Flying Horse ~~North PUD/SP Amendment~~ (Filing 9)
Final Drainage Report Amendment

September 2026

PCD File No. SF2625

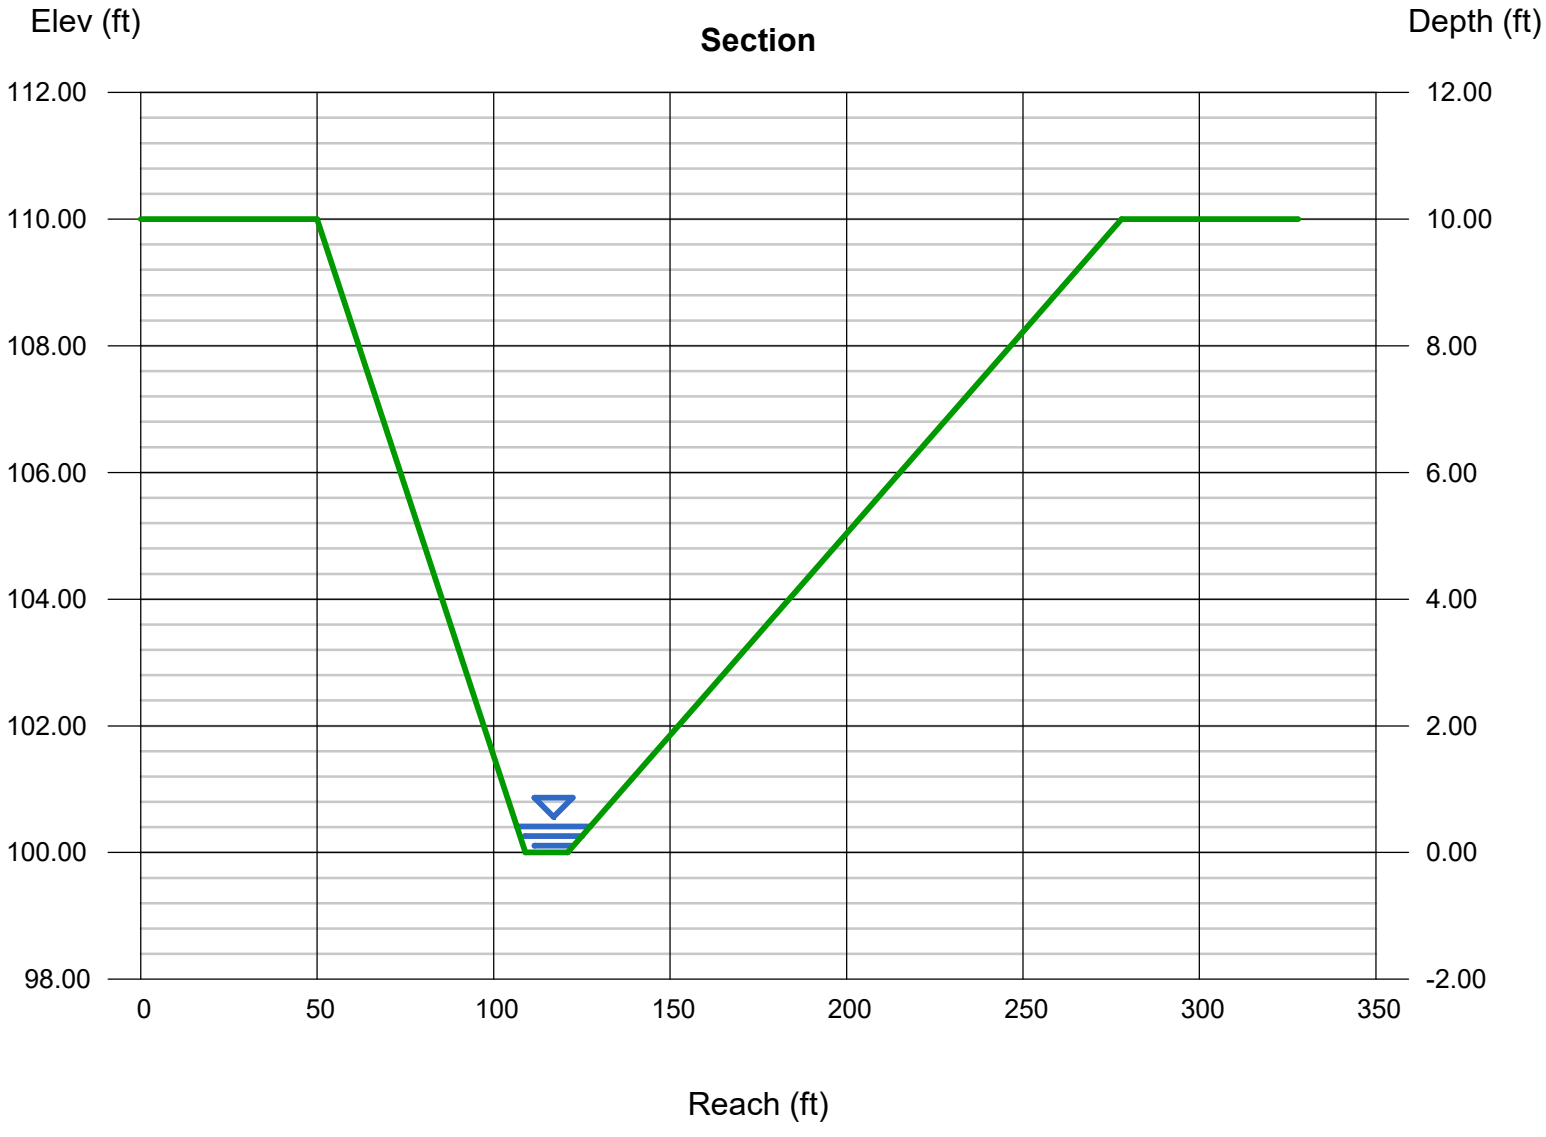
These values do not match the depths generated for the channel reports on the subsequent pages. Please review and revise as needed.
